Product Change Notification

1. ECR #: 218869
Notification #: 658

3. Series:
• UMPS - UMPS ASSEMBLY

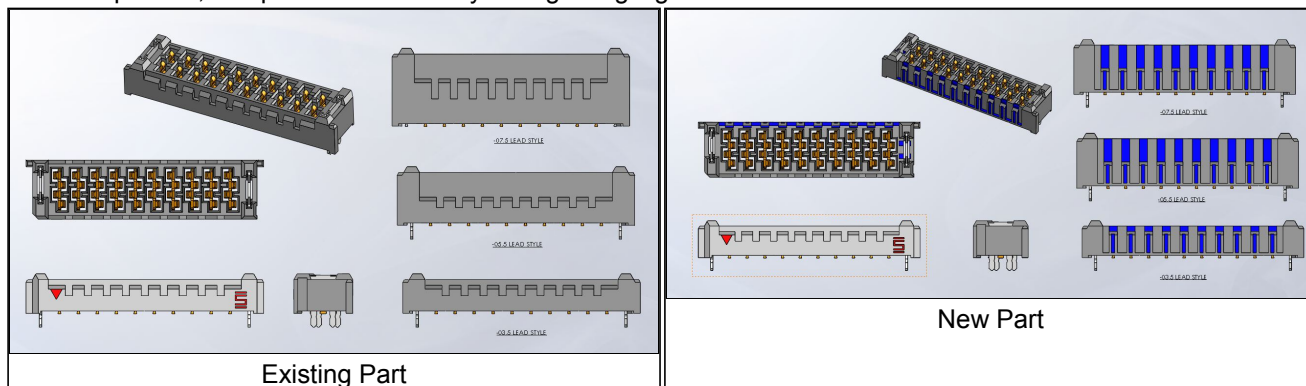
5. Description of Change:
Change the outer void of side rib design and add void to right Weld tab hole.

Visual inspection, see picture for the body changes highlighted in blue color.

7. Reason for Change:
Change made to improve body knit line.
